ADDENDUM NO. 3

RE: Item #13, March 5, 2025 Letting - NH 0081(114)0, PCN 07DH, Yankton County - ADA, Modify Intersection, Signals

PLANS: Please destroy sheets A2, L2, L3, L4, L5, L11 and L21 and replace with the enclosed sheets, dated

STATE OF SOUTH DAKOTA	PROJECT	SHEET L5	TOTAL SHEETS
	NH 0081(114)0		L43

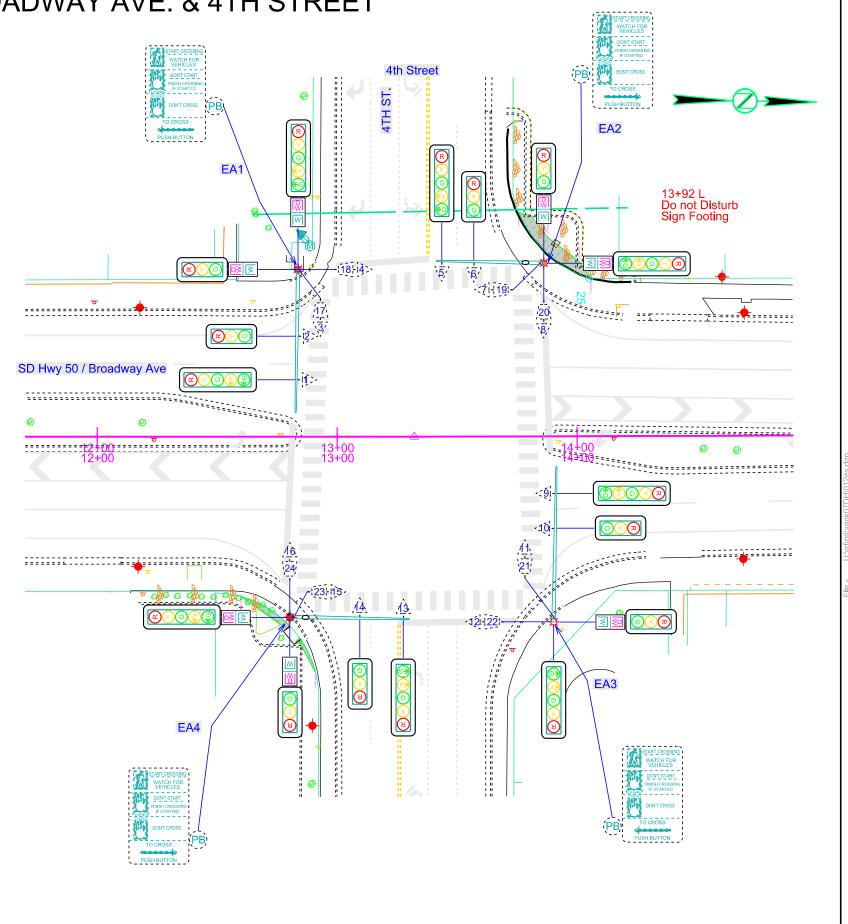
Sheet L5: Note placement was adjusted.
